Date February 15, 2023
To Town of Cumberland Planning Board
From Carla Nixon, Town Planner
Subject **Subdivision Amendment: Elizabeth Johnson Subdivision**

7. TOWN ENGINEER REVIEW: Dan Diffin, P.E., Sevee and Maher Engineers.

Thank you for your February 1, 2023 review comments for the 104 Foreside Road, Cumberland Foreside project that involves a lot split from a previous subdivision. I have provided a response (bold text) to address your concerns in the same format as your letter.

Re: Revised Stormwater Quantity/Quality Narrative, 104 Foreside Road, Cumberland, Me (updated 02-05-2023, Lot A)

SHEET C1

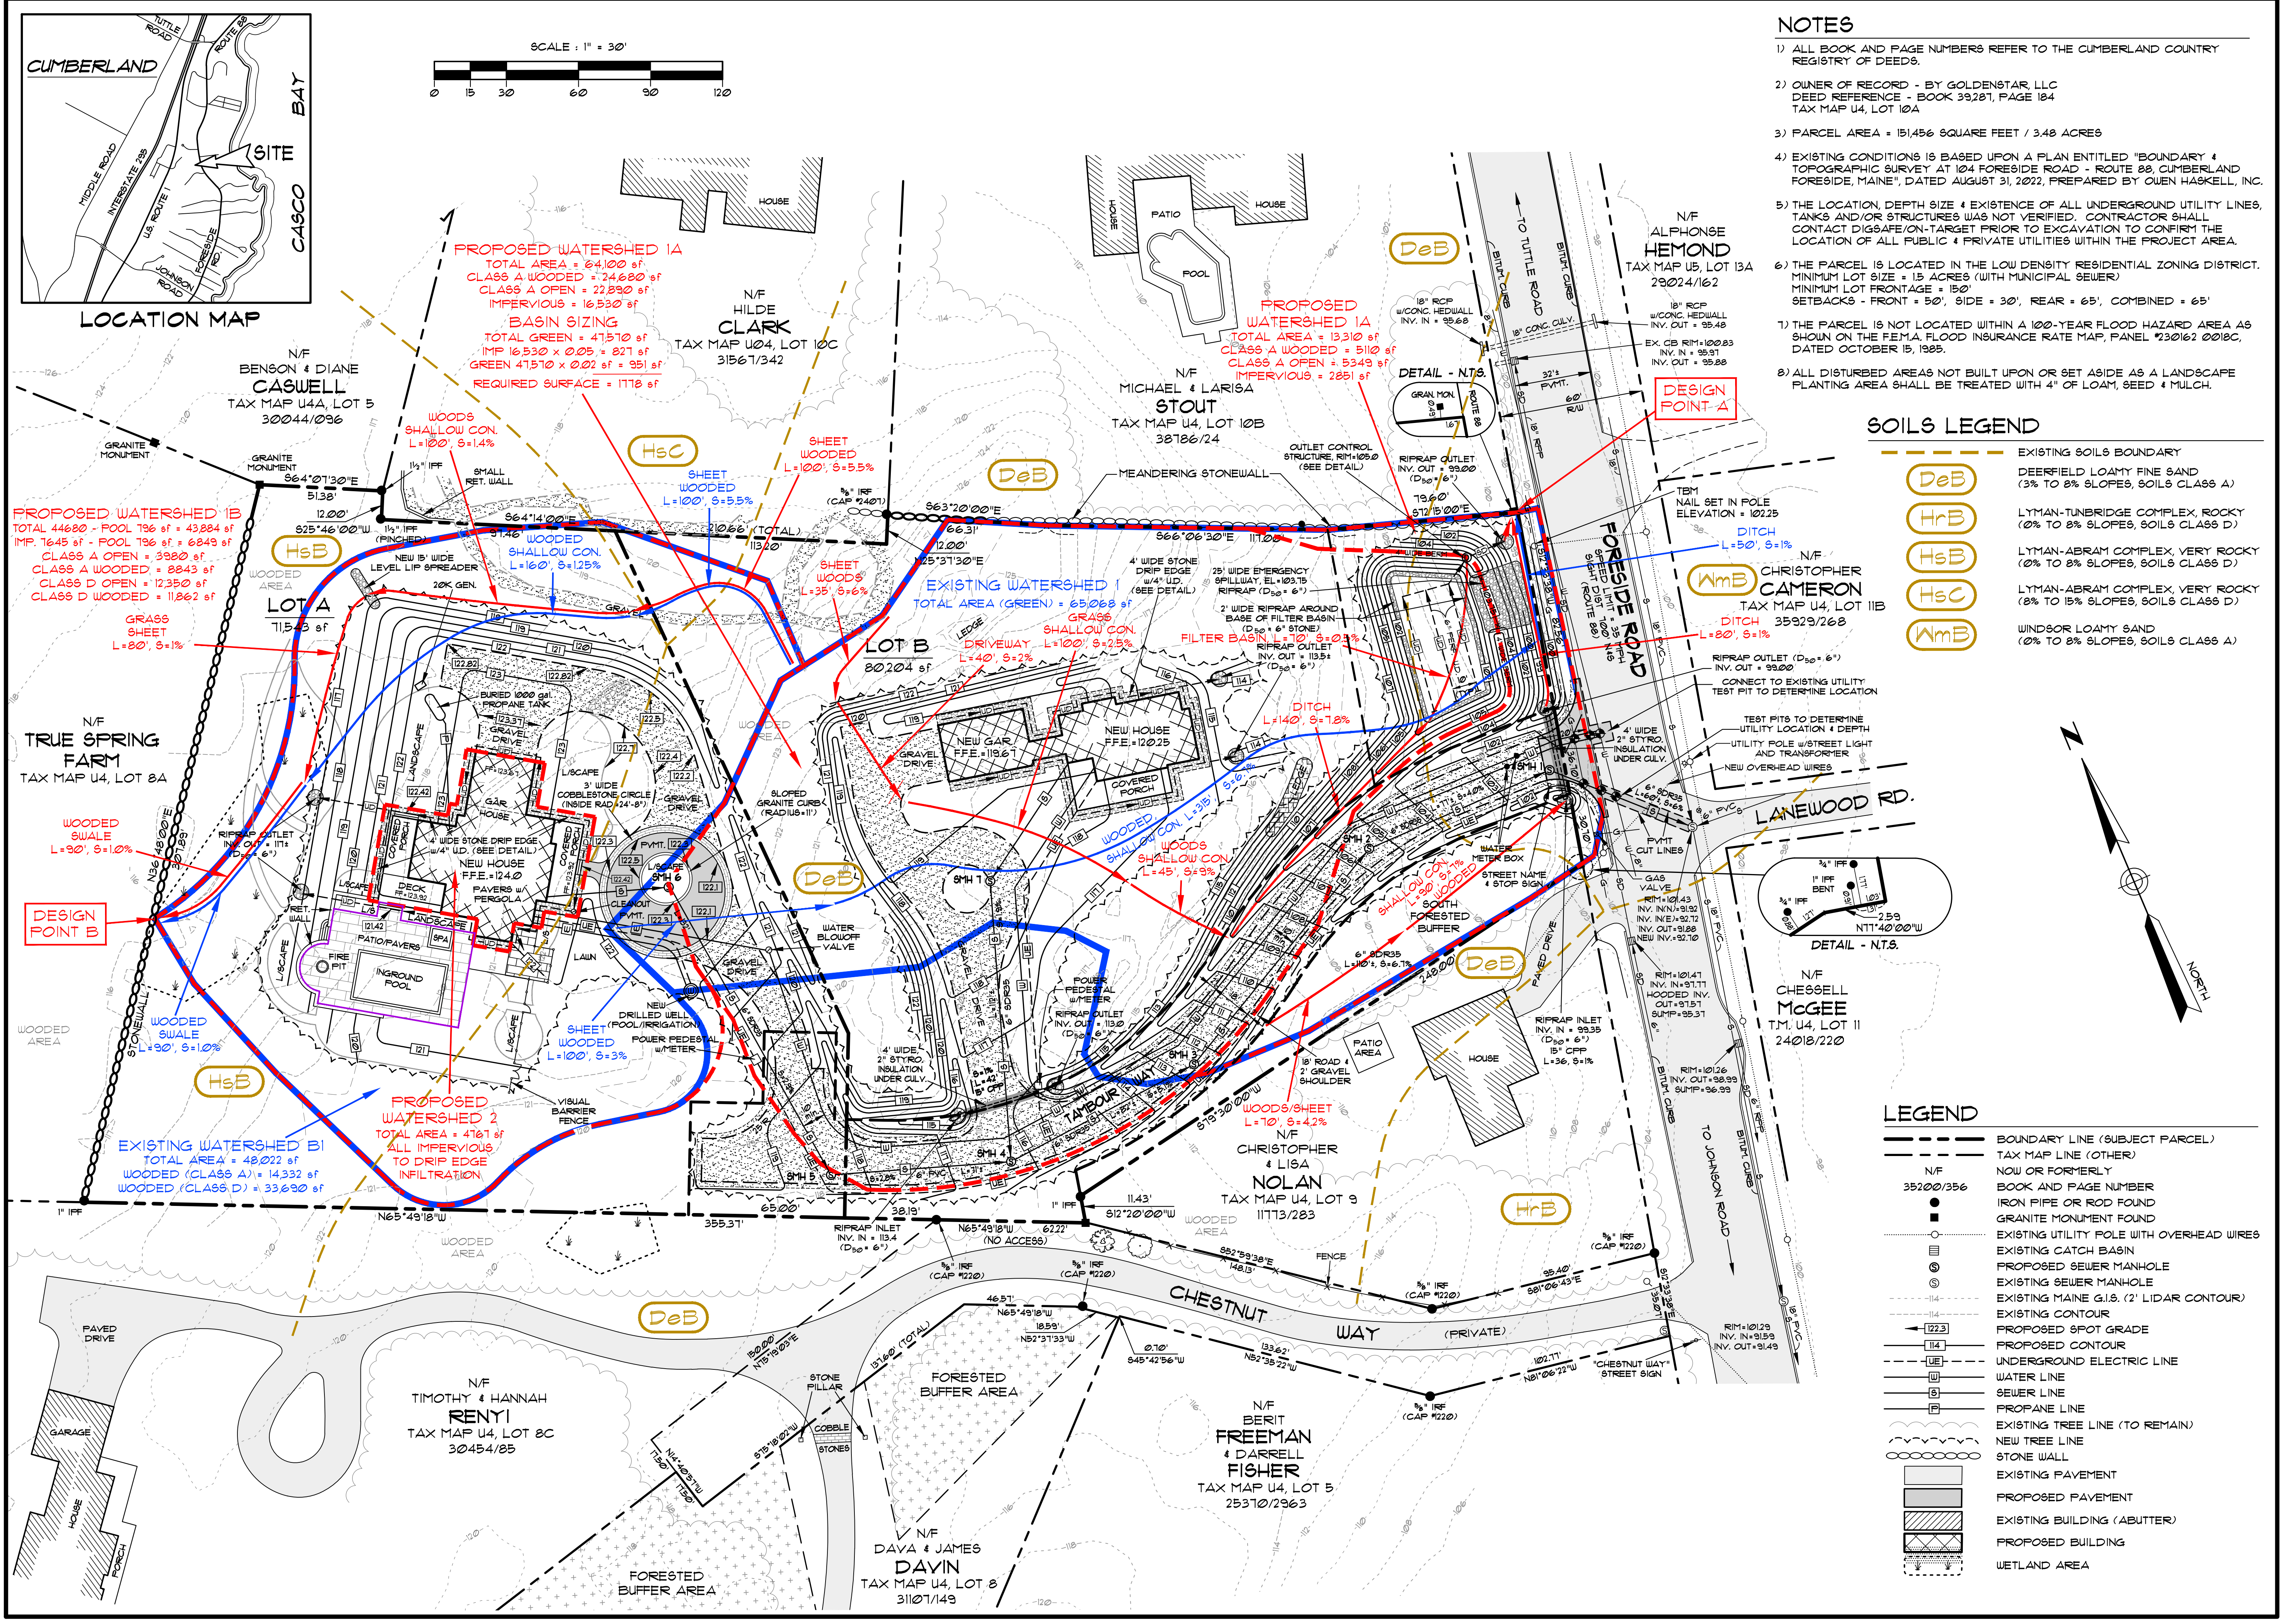
1. SME recommends that the Applicant include both Lot A and Lot B in the drainage analysis to demonstrate that flows are being adequately controlled before leaving the property. This will document that the abutting properties will not be adversely affected by the development of either lot. Alternatively, please provide calculations from the previous subdivision application demonstrating that the development on the Proposed Lot A is the same size and drains to the same area as the previously approved plan.

Reply: I have attached the stormwater analysis for Lot A (and Lot B) for subdivision review. In summary, proposed stormwater flows for the 2, 10, and 25 year storm events show reduced flow rates at Design Point B (rear wetland).

SHEET C12

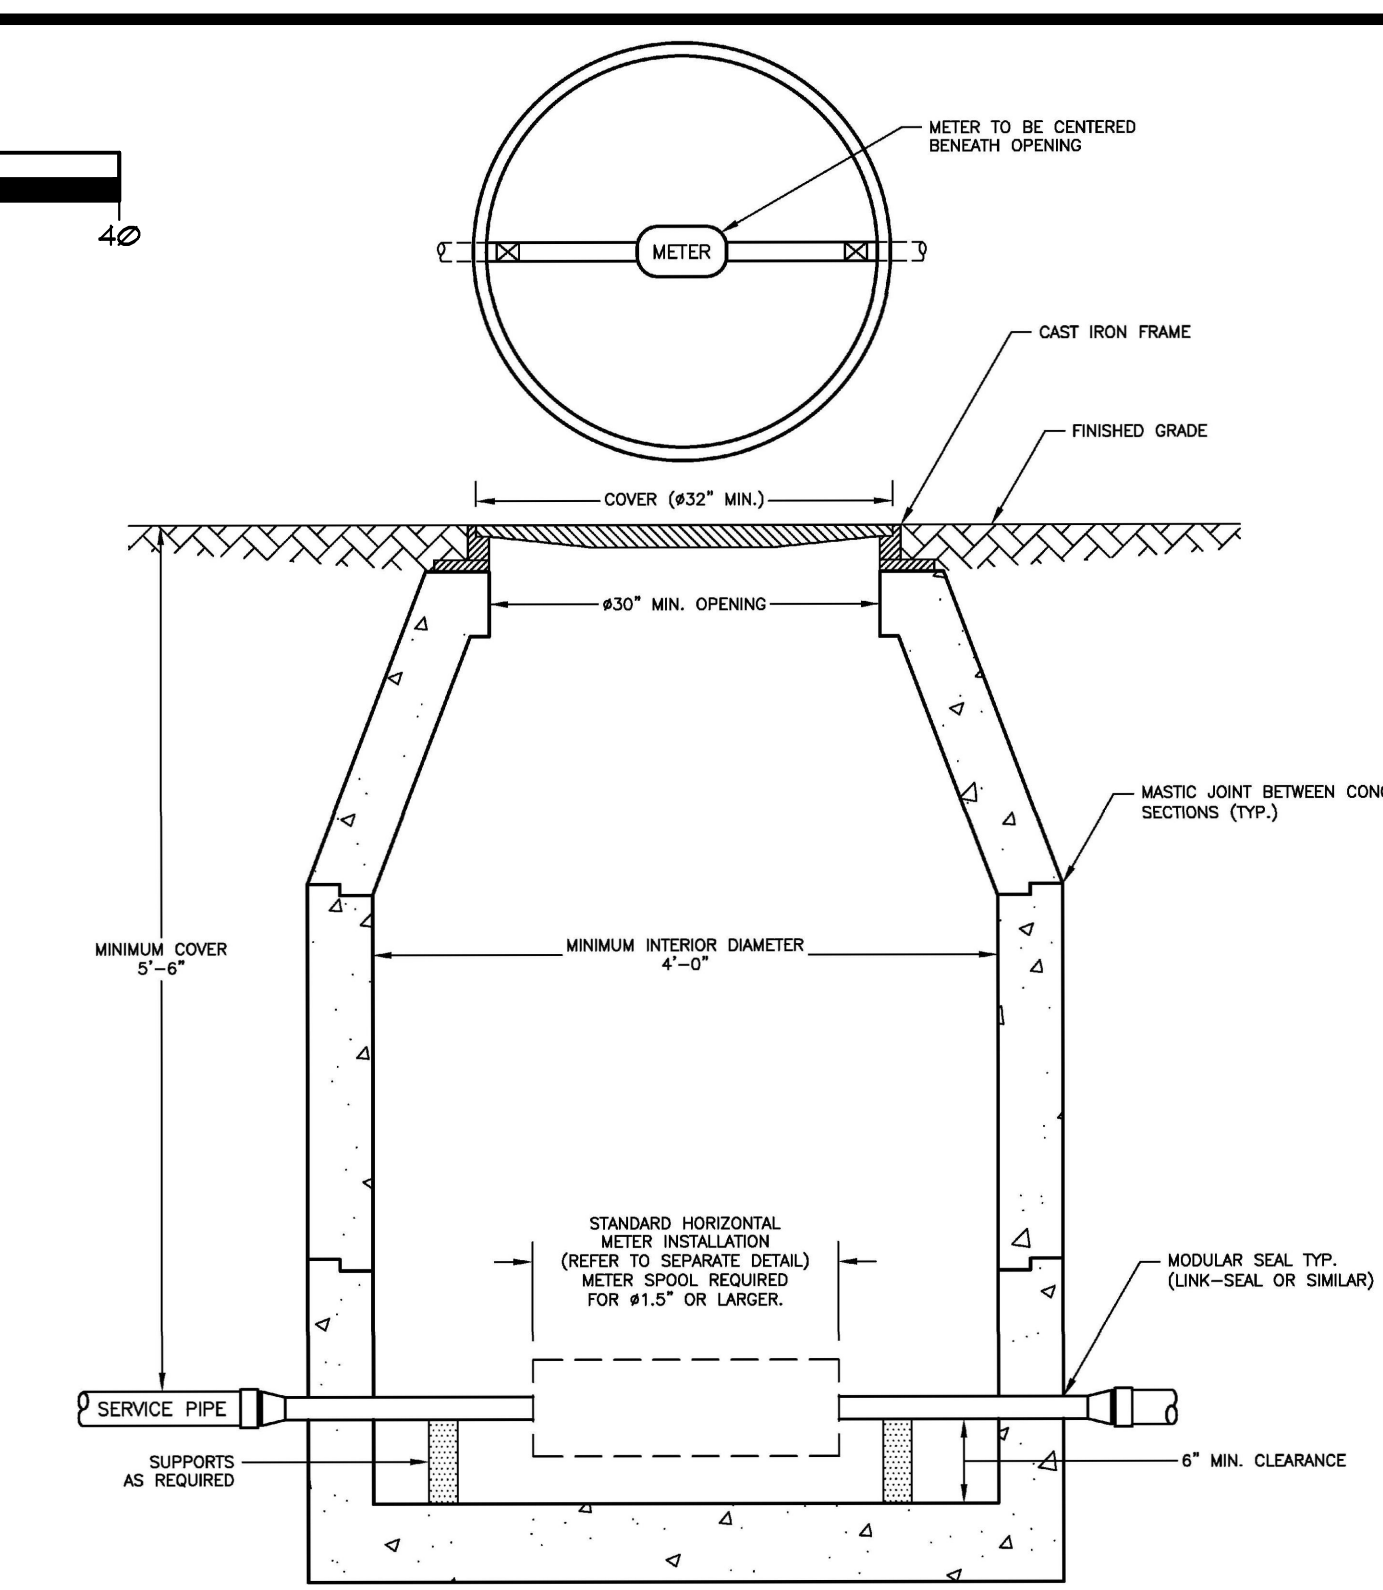
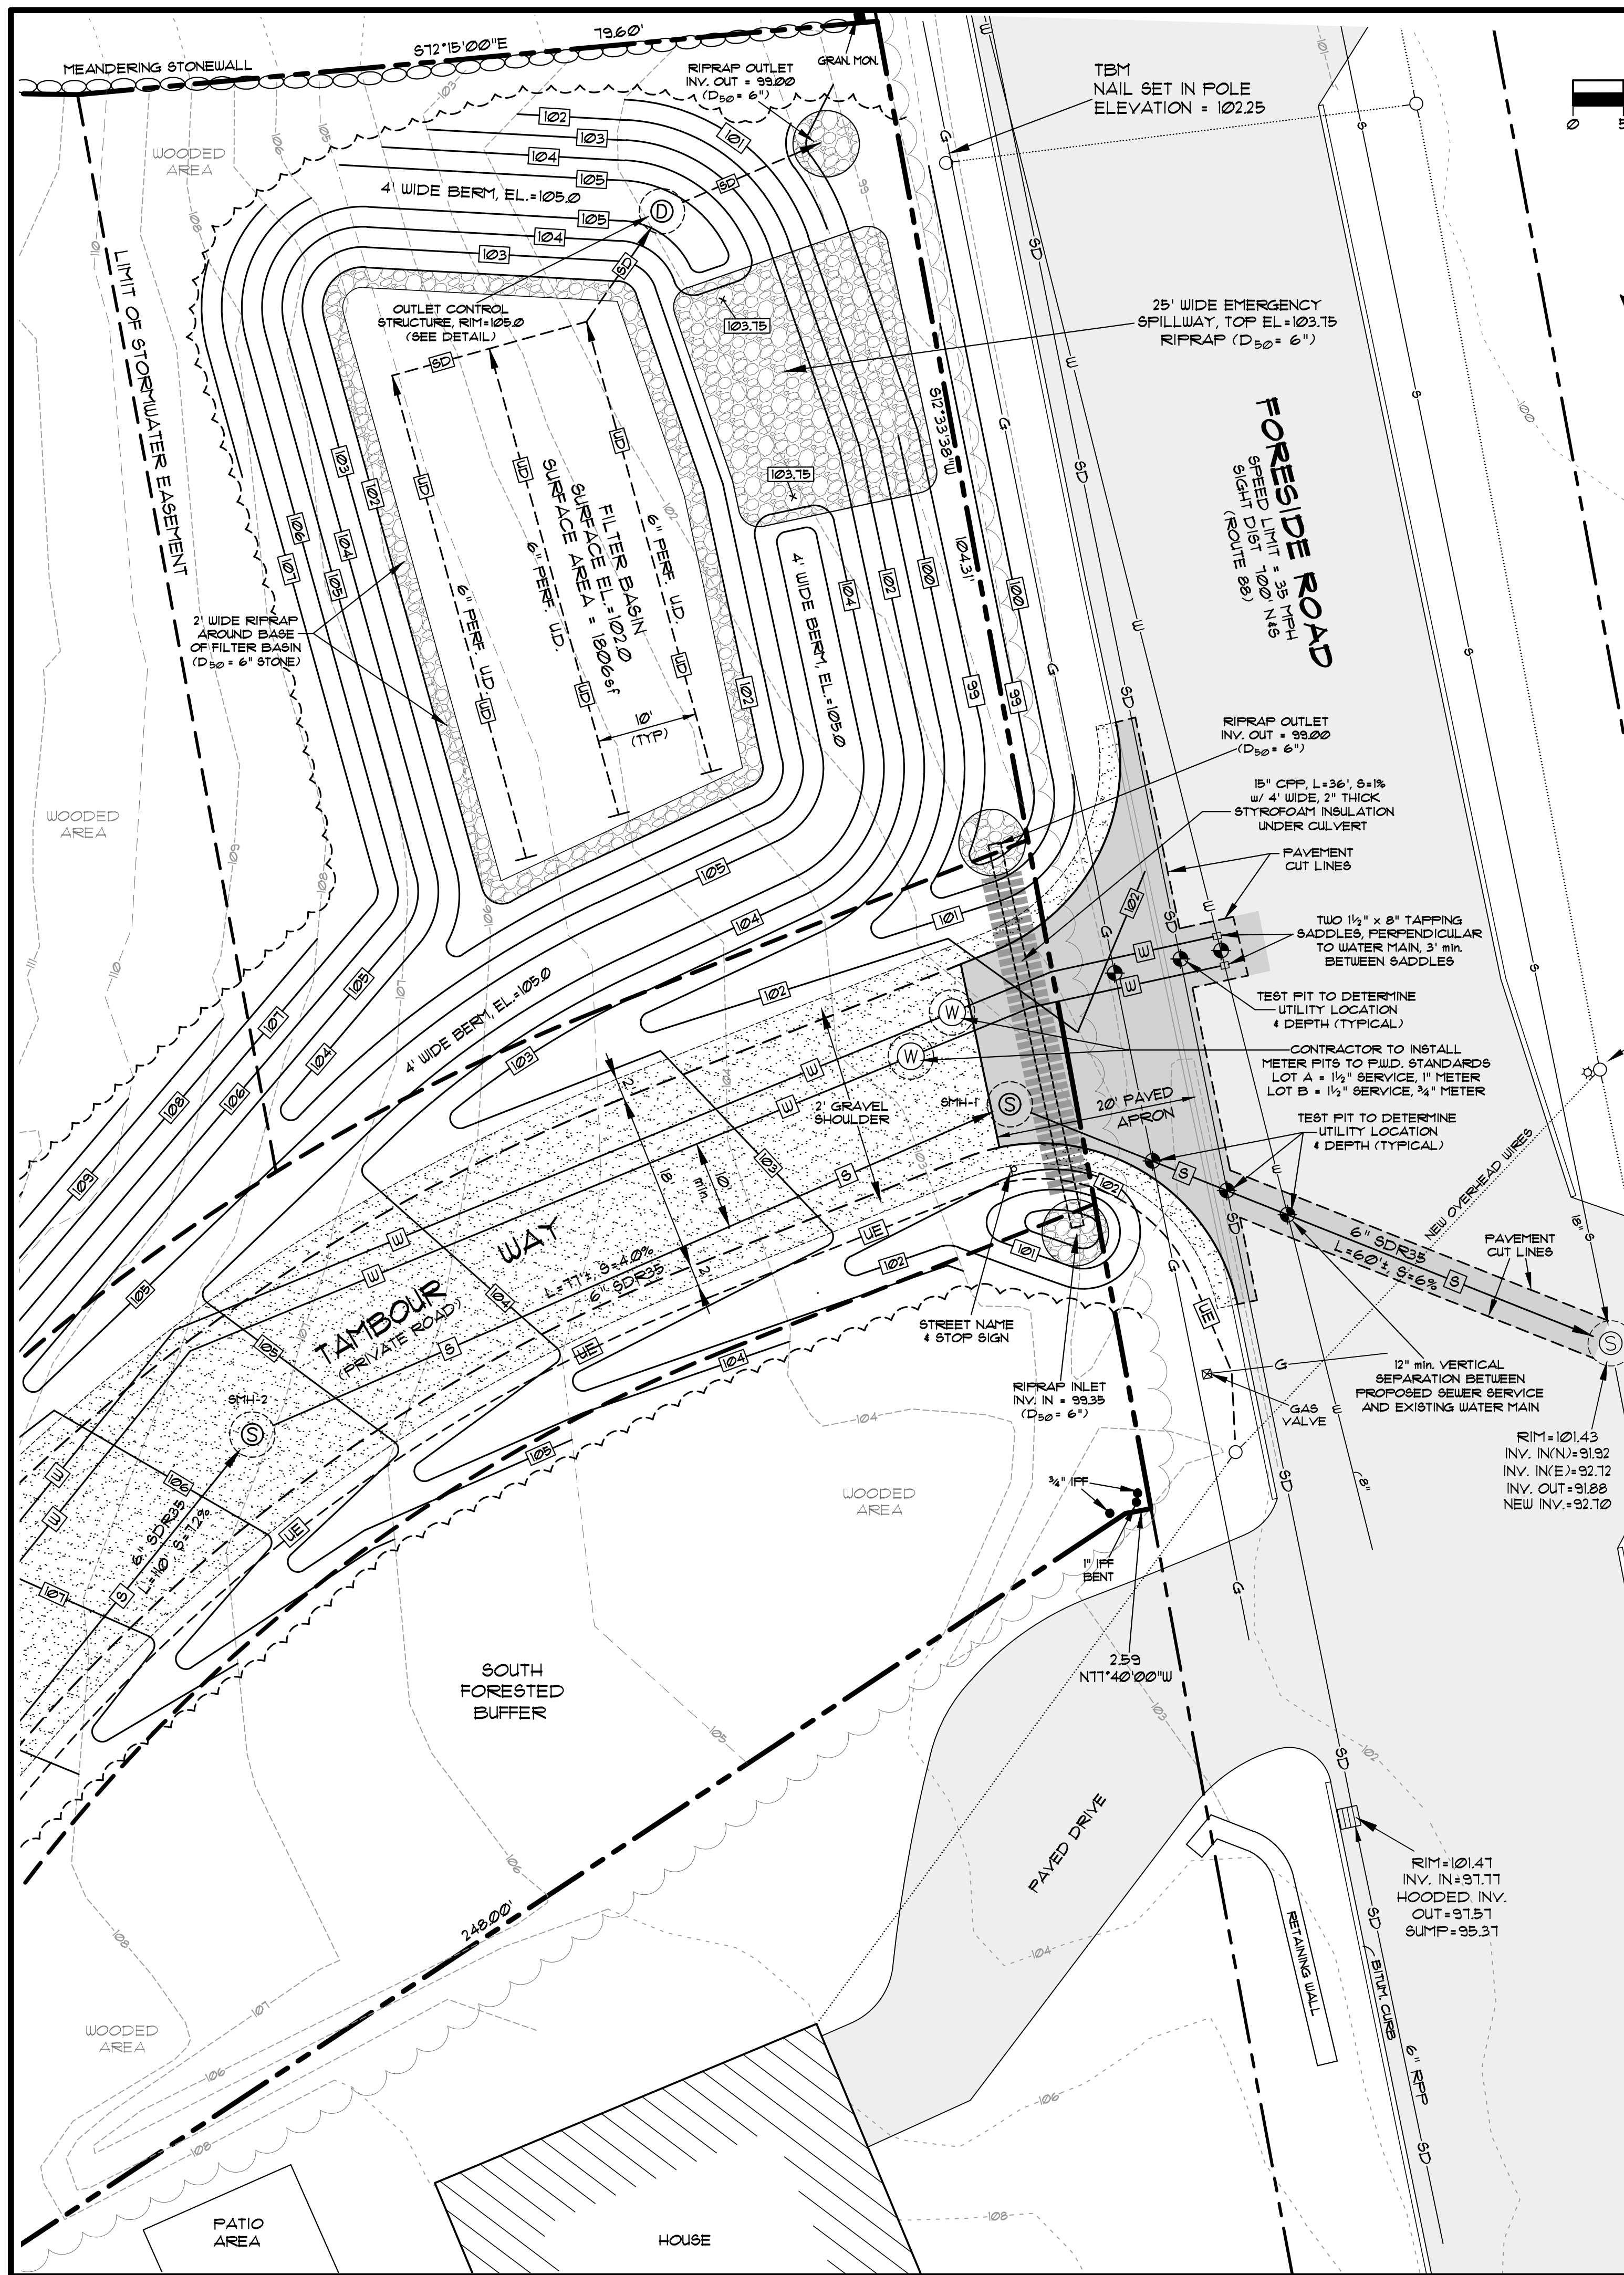
3. There is no design information provided on the plans for the common sewer and water main size in the proposed road or where it ties into the public main in Foreside Road. Please provide design information on the proposed utilities. There appears to be an existing 6-inch sewer main stub available to the project as shown on the attached sewer service card provided by the Town.

Reply: I'm not sure why the sewer information was not provided to SME. The sewer design is shown on sheets C11 and the 10 scale sheet 12. I've

attached those plans with this submission.
